10.2 Turbine Generator

The information in this section of the reference ABWR DCD, including all subsections, tables and figures, is incorporated by reference with the following departures and supplements.

Figure 10.2-1 Turbine Stop Valve Closure Characteristic

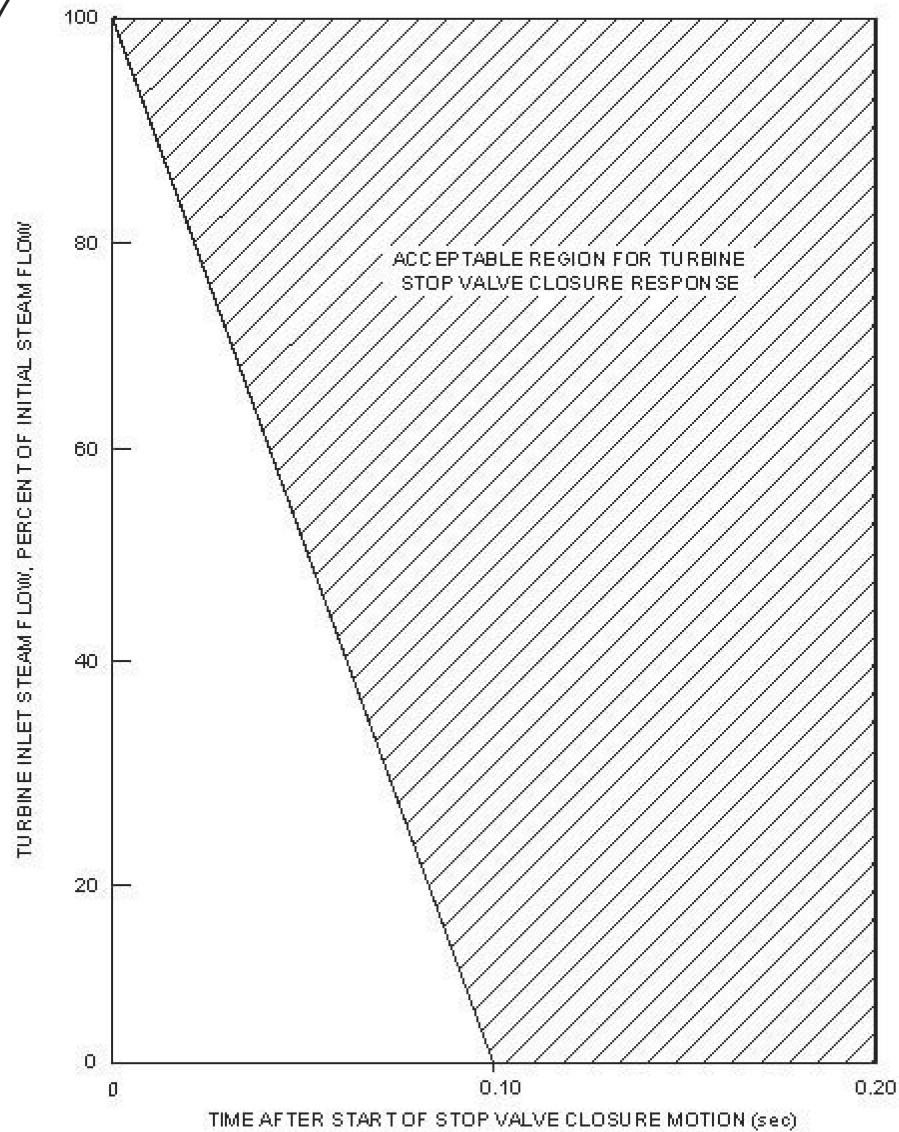
STD DEP Admin (Figure 10.2-1)

Figure 10.2-4 Generator Hydrogen and CO₂ System

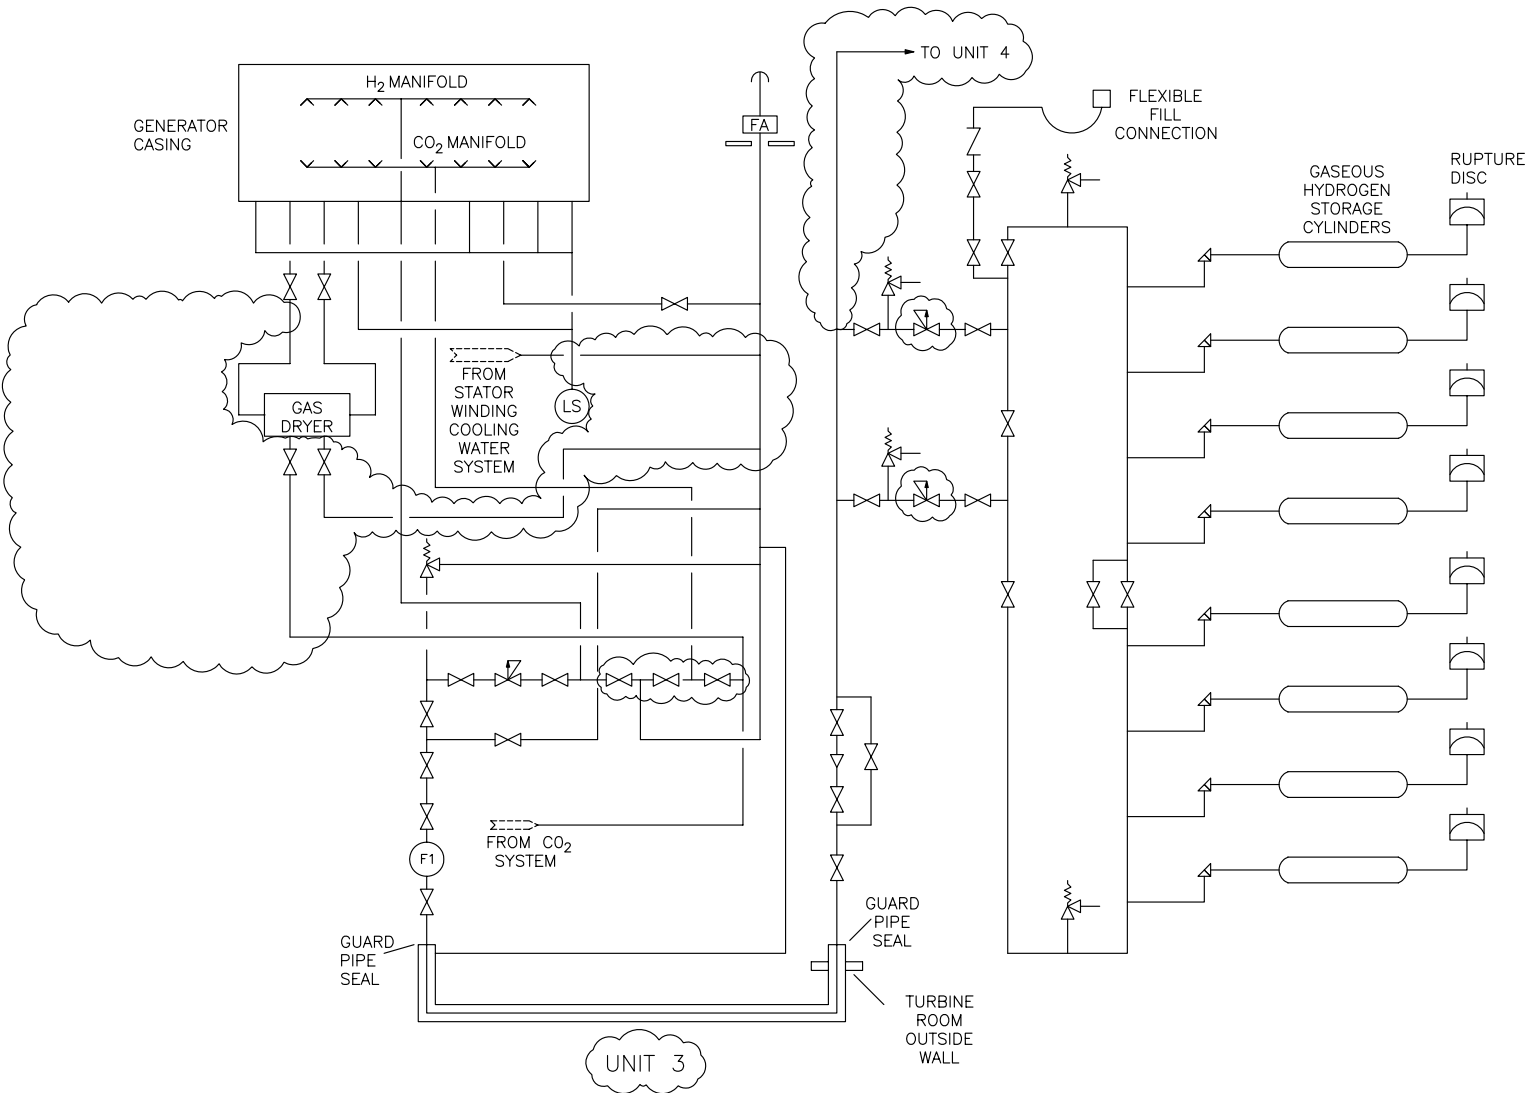
STP DEP 1.1-2 (Figure 10.2-4)

STP DEP 10.2-1 (Figure 10.2-4)

Bulk Hydrogen System—The bulk hydrogen and CO₂ system is illustrated on Figure 10.2-4. The hydrogen system is designed to provide the necessary flow and pressure at the main generator for purging carbon dioxide during startup and supply makeup hydrogen for generator leakage during normal operation.
